HOWARD COUNTY HISTORIC PRESERVATION COMMISSION
ELLICOTT CITY HISTORIC DISTRICT ■ LAWYERS HILL HISTORIC DISTRICT
3430 Court House Drive ■ Ellicott City, Maryland 21043

May Minutes

Thursday, May 6, 2021; 7:00 p.m.

Figure 12 - Proposed Western States seam type

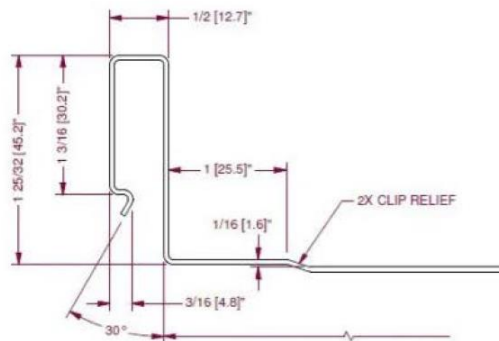
- d. Roof – Install Western States metal roofing, in a standing seam style. The roof will be black and the panels will be 18 inches wide. The seam style is shown below in Figure 12.

- 2) Make repairs and alterations to the existing historic house.
 - a. Roof – Remove existing asphalt roof and install Western States metal roofing, in a standing seam style. The roof will be black and the panels will be 18 inches wide. The seam style is shown below in Figure 12.

The proposed roofing on the porch enclosure will be black standing seam metal, which is also proposed to be installed on the main historic house. In both cases asphalt shingles will be removed for the installation of the metal roofing, which is a more historically appropriate roofing type than asphalt. While it is unknown if a metal roof ever existed on this structure, it is reasonable that the roof would have originally been wood shingle and could have been converted to metal and later, asphalt. The Western States standing seam metal roofing appears to only come in one profile, unlike other metal roofs the Commission has reviewed. The seam is slightly wider and more square than previous roofs the Commission has approved, with the goal to have a machine-made standing seam look more like a hand seam. Figure 12 below shows the proposed seam type, while Figure 13 shows the seam type the Commission has reviewed in past applications.

Figure 21 - Proposed ADA parking space and location of ramp.

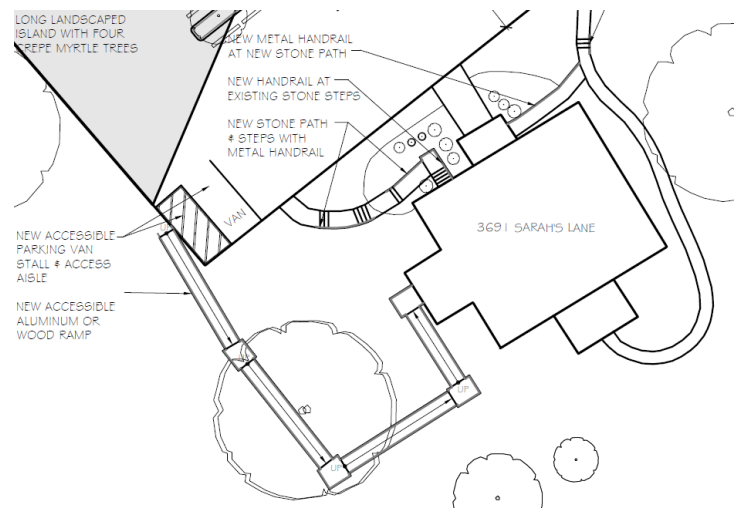
The location of the ramp complies with the Guideline recommendations. The ramp will not damage or obscure key architectural features of the building. The Applicant originally wanted to install the ramp at the existing service entrance on the front/northwest side of the building (historically the rear), but the grade change did not work.

Figure 22 - Proposed new ADA door on side of building.

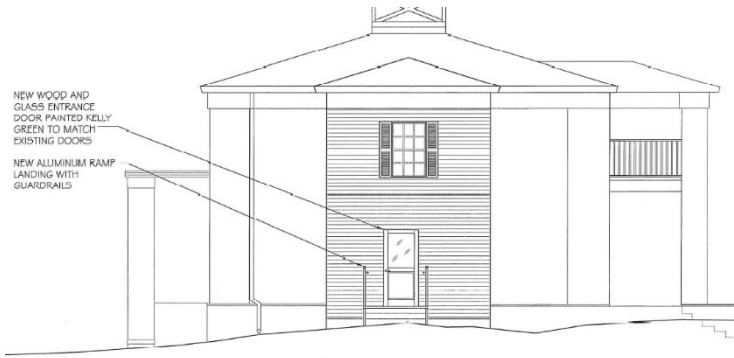
- a. Install a wood ADA entry door on the side building addition. The new door will match the green color on the existing doors.
- b. Install a fabricated metal ramp or a wood ramp at the building addition. The ramp is to be installed on the far-right side of the parking lot (if facing the building) and will lead to a side door on the addition. The ramp will consist of three section of approximately 30 feet and one section of approximately 15 feet, for a total of 105 feet ADA compliant ramp, with compliant platforms every 30 feet. The aluminum ramp would be silver and the wood ramp would be pressure treated wood stained Behr Harbor Gray.

Figure 25 - Existing and proposed site plan.

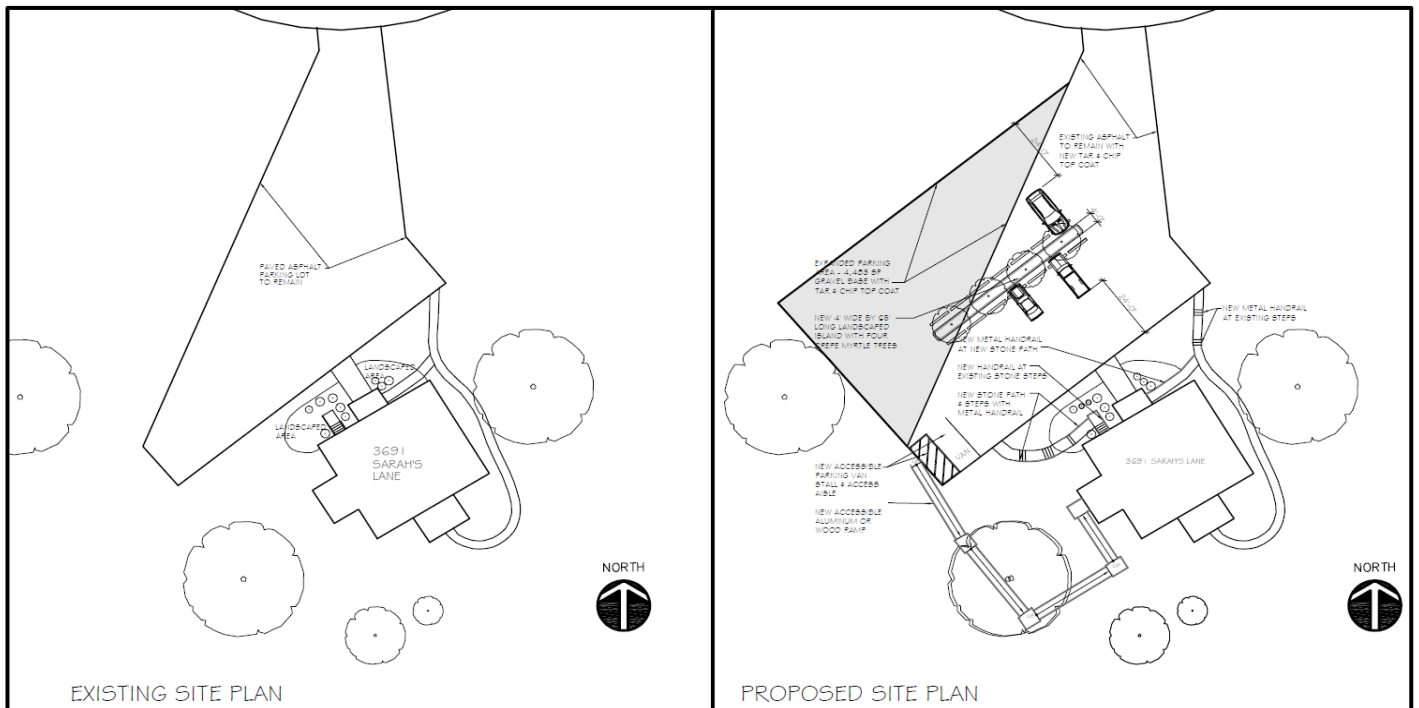
Creating a parking lot directly in front of a historic building would not be recommended, as typically a drop off or circular driveway is most appropriate. However, this parking lot currently exists adjacent to the entrance. Aerial photography dating to the 1970s/1980s shows the lot has been triangular in shape. The proposal to make the parking lot more rectangular is practical for the design of a parking lot, but the lot should not be larger than necessary in order to comply with the Guidelines. The proposed expansion of parking is 4,483 square feet and the site plan does not provide overall measurements of the parking lot, but it appears the final proposed lot would be close to 10,000 square feet of finished parking. The existing linear parking is approximately 120 feet, accommodating a row of an estimated 12-13 spaces, pending ADA parking (using the standard 9x18 foot size of a parking space).

Ms. Zoren said the parking is an inefficient layout. She said in the same space, more spaces could be achieved by double loading the island and shifting the island and adding a drop off zone. Ms. Zoren displayed a sketch showing an alternate parking scenario that achieves more spaces and reduces the lot width. Ms. Kepnes explained that while this is the view of the building from the road, it is the back of the building. She is trying to pull the spaces away from the building and does not want to create parking in the grass area, as recommend by Mr. Roth, which she finds to be part of the viewscape. She said the property looking to the left is an important aspect. She said pulling the parking back from the building achieves that viewshed.

Figure 26 - Example of proposed aluminum ramp.

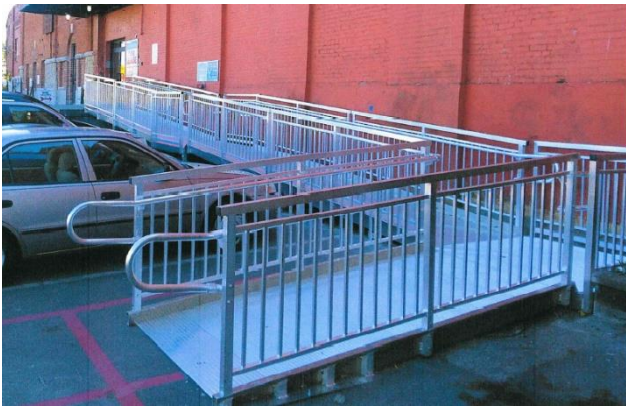
The proposal to construct the ramp out of silver/unpainted aluminum does not comply with the Guideline recommendations, as it is not common to see silver aluminum materials in the district. One alternative type that would better comply is a black metal ramp; an example is shown below in Figure 28. A black metal ramp would better blend with the new black metal railings proposed for use on the property and black metal is a common fencing/railing type found in the district. Adding ADA accessibility to the structure is appropriate but should fully comply with the ADA requirements, including slope, railings, landings and parking layout. The other proposal to construct a wood ramp out of stained wood complies with the Guidelines, but a metal ADA railing may still need to be added for compliance, as shown in Figure 29. A ramp is for wheelchair accessibility, but ADA requirements also are intended to accommodate all disabilities such as blindness or walking disabilities beyond the wheelchair, so all factors for accommodations should be considered.

Figure 32 - Ms. Zoren's sketch during the meeting, showing the double loaded parking and a T-landscape island.

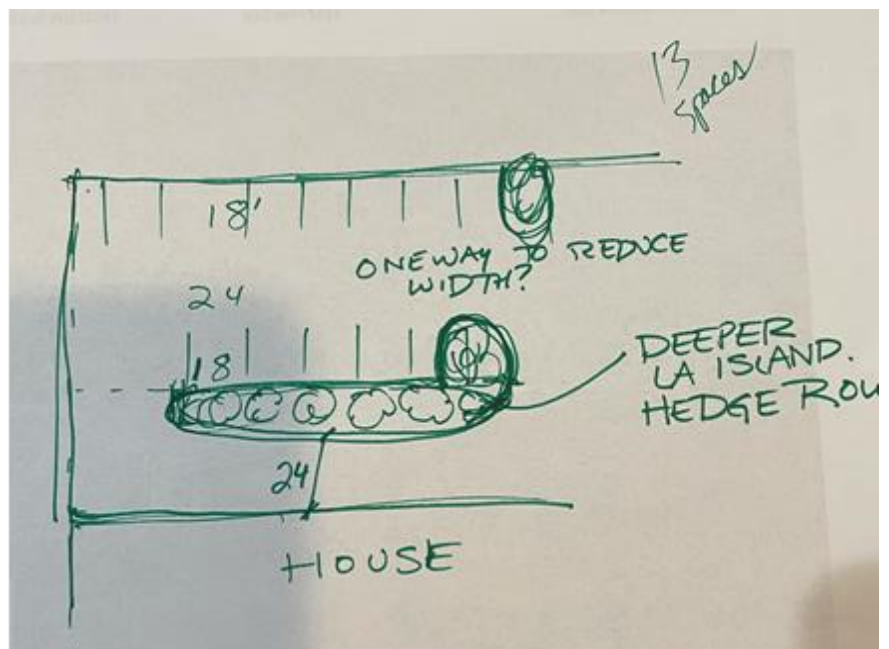
Ms. Zoren requested a hedgerow to shield the metal ramp. She recommended leveling the existing grade of the ADA space, cutting 12-20 feet off the ramp, by bringing up the corner where the ramp starts. Ms. Zoren said part of it would be sidewalk as well, leading to the ramp.
